Safety Bay Road extension, Baldivis

**Report and recommendations
of the Environmental Protection Authority**

**Environmental Protection Authority
Perth, Western Australia
Bulletin 678
April 1993**

Figure 4: Route options in CER.

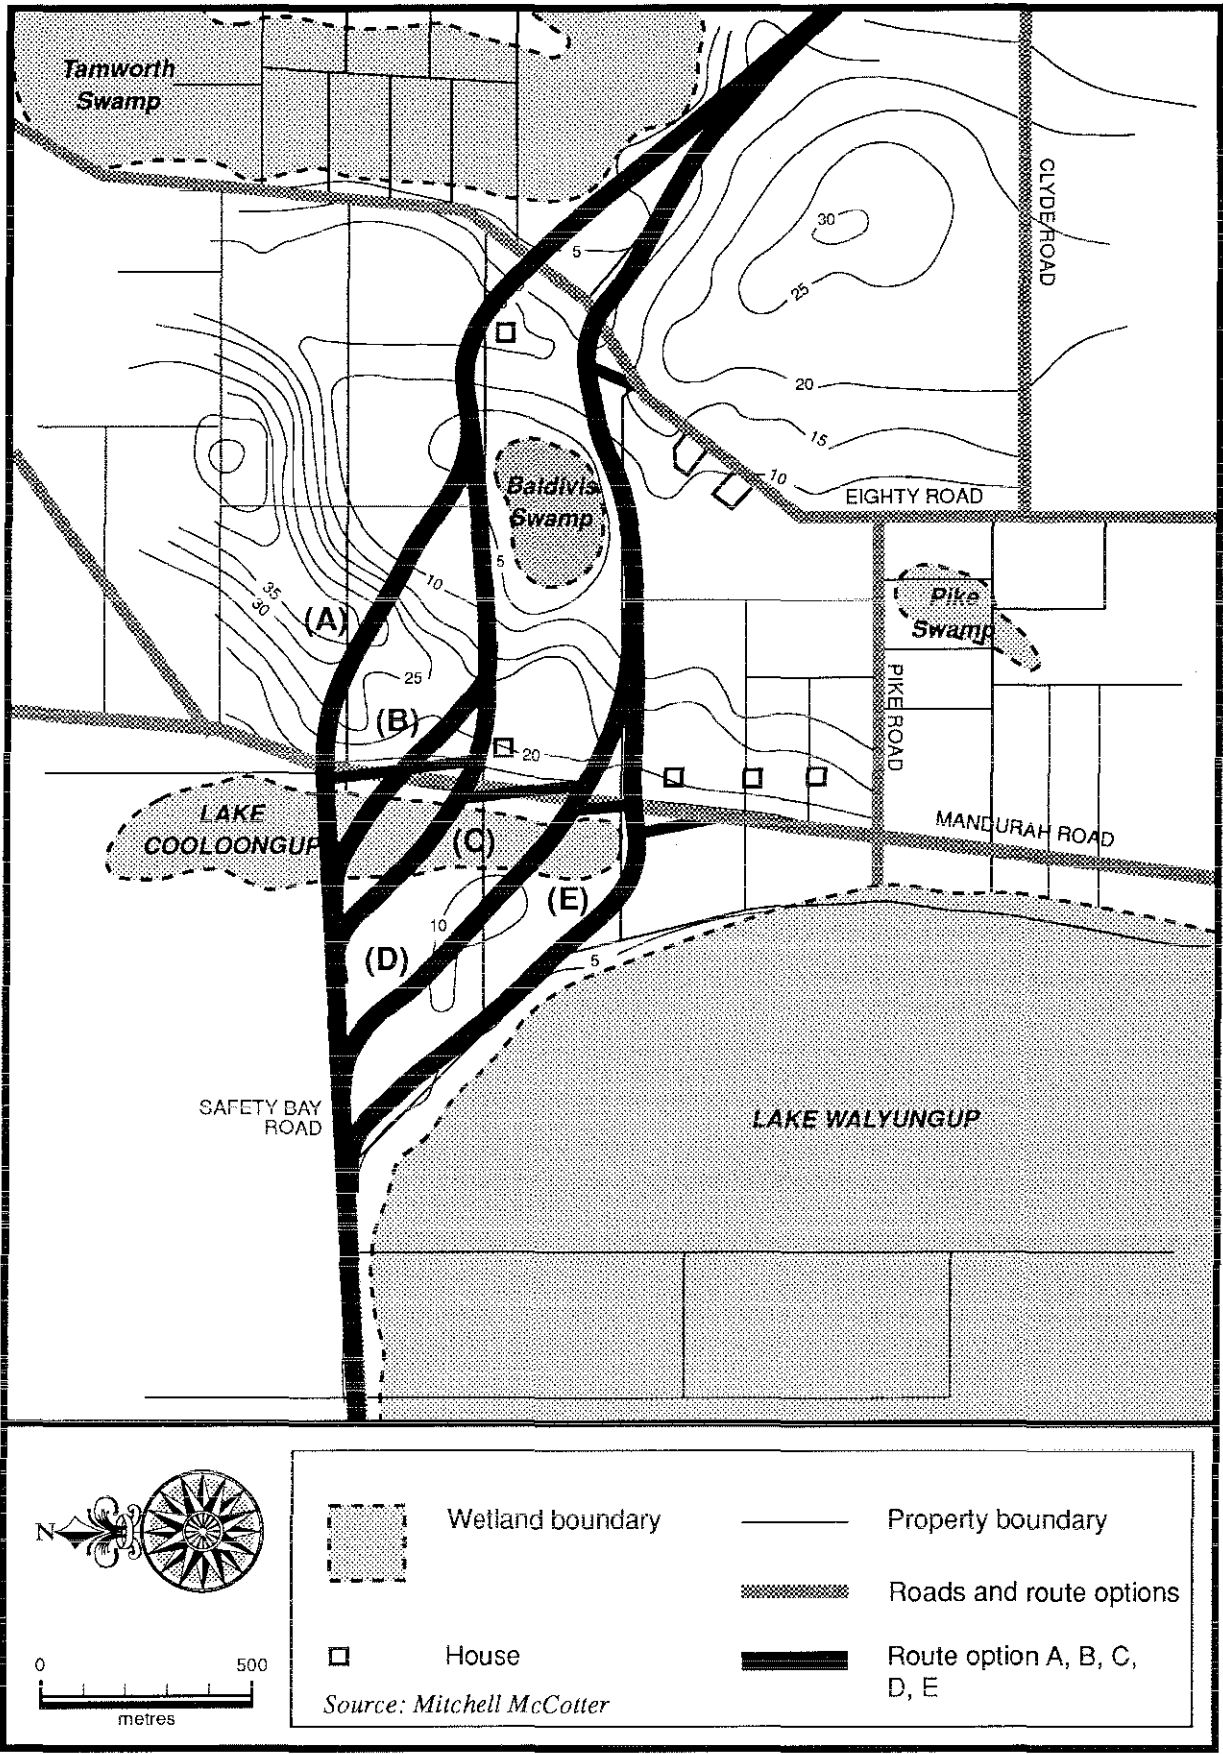
The Environmental Protection Authority has evaluated each of the options presented in the Consultative Environmental Review (refer figure 4) in terms of their potential environmental impact on the key aspects of the environment which the Environmental Protection Authority is seeking to protect. The alignment progressed by the proponent will require an amendment to the Metropolitan Region Scheme through the planning process. The Environmental Protection Authority considers that this process is best suited to addressing the relationship between the finally approved route and any affected residents.

Option E is the proponent's preferred option. Option E impacts the greatest on System Six M103 in terms of length of disturbance, but does not impact significantly in terms of flora and fauna or on the hydrology of the lakes. Option E does not have significant additional impact on Lake Coo loongup as it passes to the bottom of the area in best natural condition and through an area which although in need of fill to facilitate the proposal, does not have relatively high value in terms of flora and fauna habitat (refer Figure 3). There is concern about this alignment's proximity to Baldivis Swamp and as proposed by the proponent in the responses to submissions (Appendix 2), the corridor for Option E should be moved slightly further south in the region of Lot 335 and Eighty Road to increase the distance between it and Baldivis Swamp. This option also passes slightly further south of Tamworth Hill Swamp than other options and is therefore better because it provides a greater buffer area between the road and the swamp.

The Environmental Protection Authority considers that modified Option E is preferable to the other options presented as it requires the least management to make it environmentally acceptable. Commitments given in both the Consultative Environmental Review and responses to public submissions by the proponent are sufficient to manage the potential environmental impacts of Option E. Options A and B require further specific and intensive management to render them environmentally acceptable.

Figure 5: Submitters alternative route option F2.

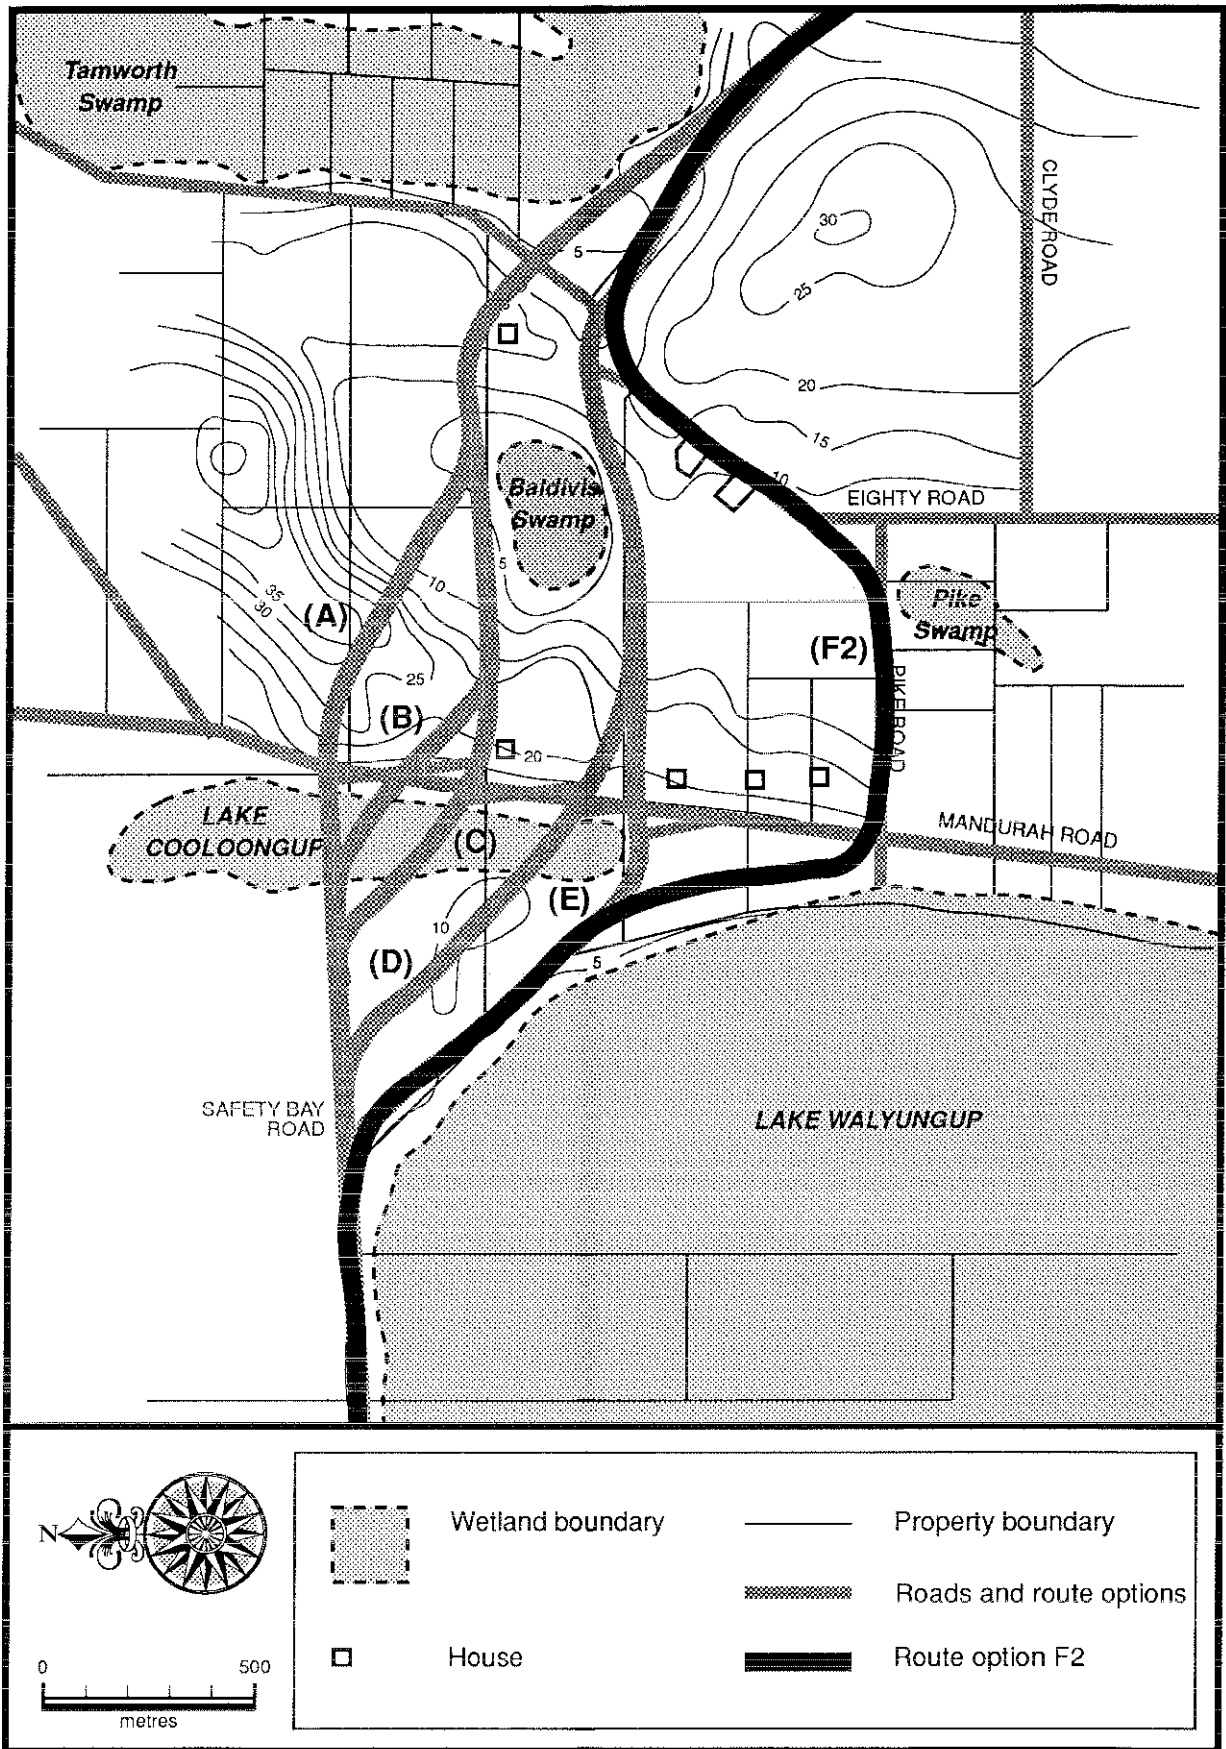
Whilst all of the routes submitted provide linkages between Mandurah Road and the future extension of the freeway, the indirect nature of Options G and F2 are undesirable given the likely volume of traffic anticipated on the road once the freeway has been constructed. Route option G deviates to the north to some considerable extent. It would require an alteration to the design and plans for the freeway to provide for the freeway junction as proposed on Lot 921. In addition, the route is not well located to service any future development of the Baldivis and North Baldivis Structure Plan areas, particularly the southern portion of the Baldivis Structure Plan area. Similarly Option F2 is not well located to service the North Baldivis area.

Figure 7: Submitters route options F and G.

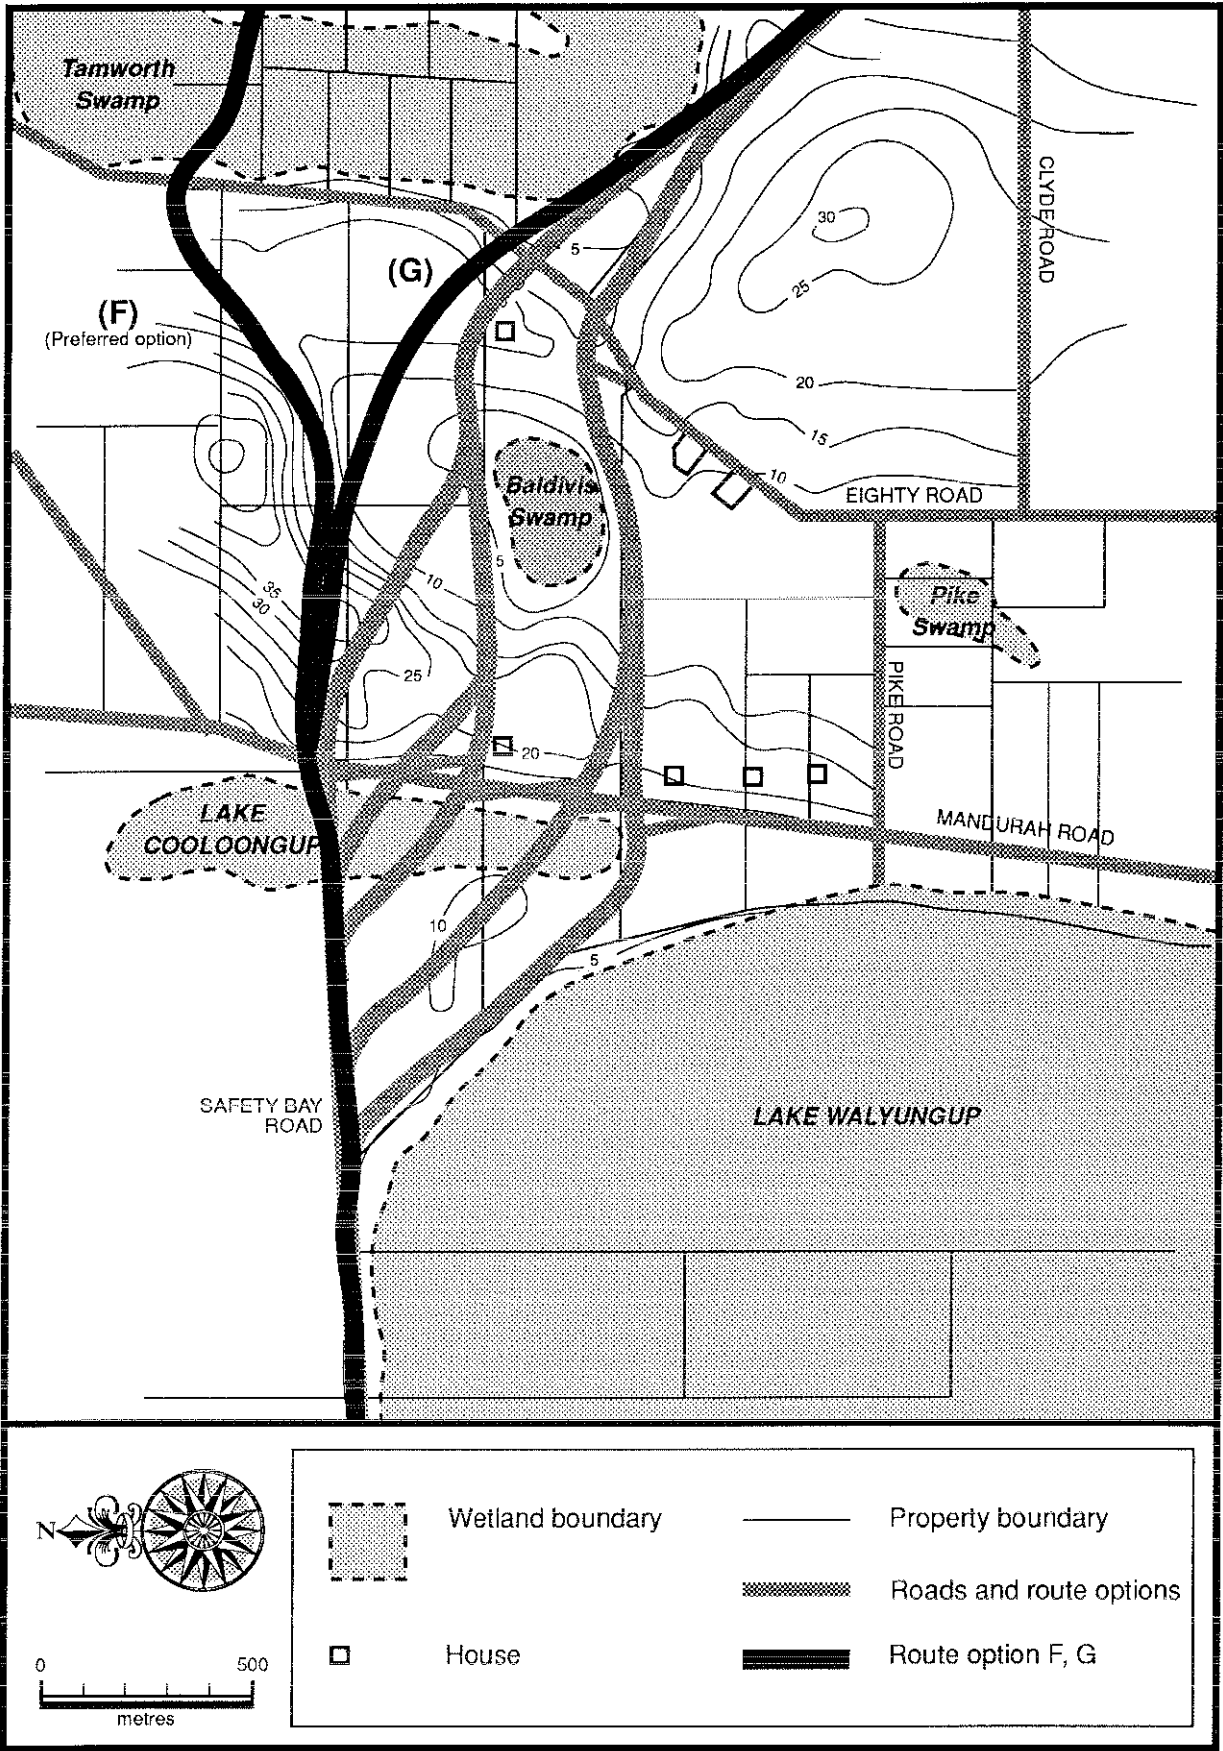
This option has similar impacts as Option F affecting System 6 on Lot 327 and cutting through the crest of Tamworth Hill. It would also provide some difficulties in achieving an acceptable intersection with Mandurah Road. It also impacts on areas assessed as having vegetation in good condition. It impacts on only one private property.

Figure 5.1
THE PREFERRED
OPTION

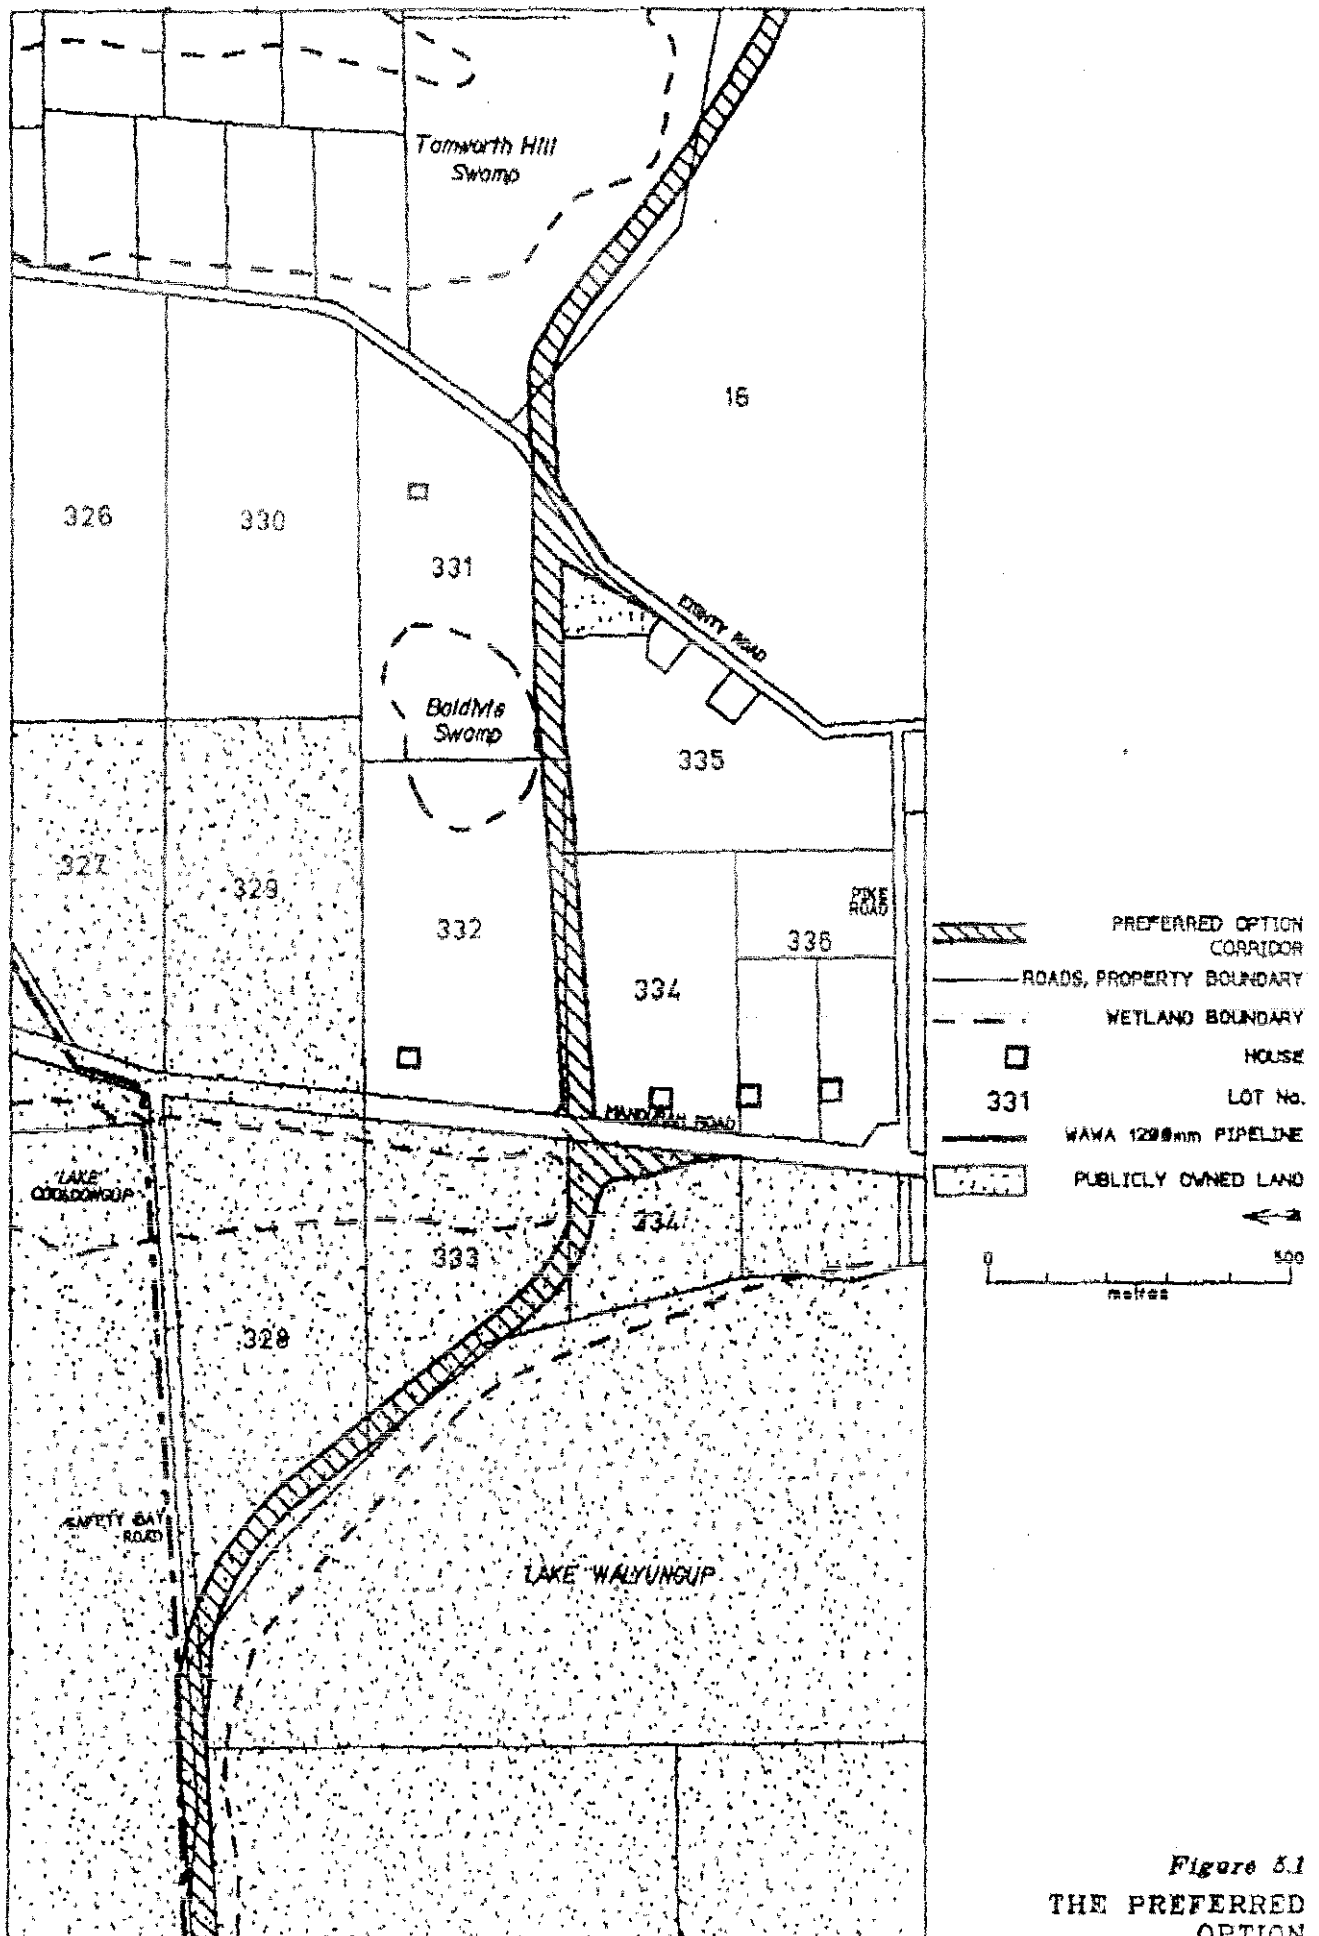
Four of the five alternative route options suggested during the public comment period have all been found to be undesirable on a range of traffic safety, landscape and environmental impacts. The alternative route option to align Option E to the northern side of the southern boundary of Lot 331 is endorsed as desirable.

On balance, therefore, it is considered that the modified Option E should remain the preferred option.
